# SITE DEVELOPMENT PLAN FOR TOWNHOMES AT WESTERN

LOT I, CIMARRON SOUTHEAST FILING NO. 2C  
LOCATED IN THE SOUTHEAST QUARTER OF SECTION 7, TOWNSHIP 14 SOUTH, RANGE 65 WEST OF THE 6TH PRINCIPAL MERIDIAN,  
EL PASO COUNTY, COLORADO

SITE DEVELOPMENT  
PLAN  
PRELIMINARY UTILITIES

DP-5 MVE PROJECT 61203  
MVE DRAWING DEV-PU

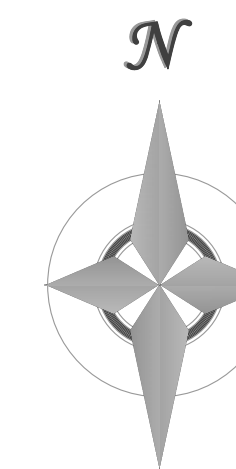
\*\* Add note "Gas meters must be a minimum of 3-feet away from any opening in walls."

\*\* Add a note stating "Six-foot minimum separation from electric and gas distribution lines."

\*\* Please show and label any proposed EV chargers and upload Load Data.

\*\* Gas and electric meter locations on plan view and building elevations must be shown and labeled.

Show and label existing 2" Gas Distribution Main CSU #P33M35

Show and label existing 12.5kV Primary UG Conductor CSU #12PF-5
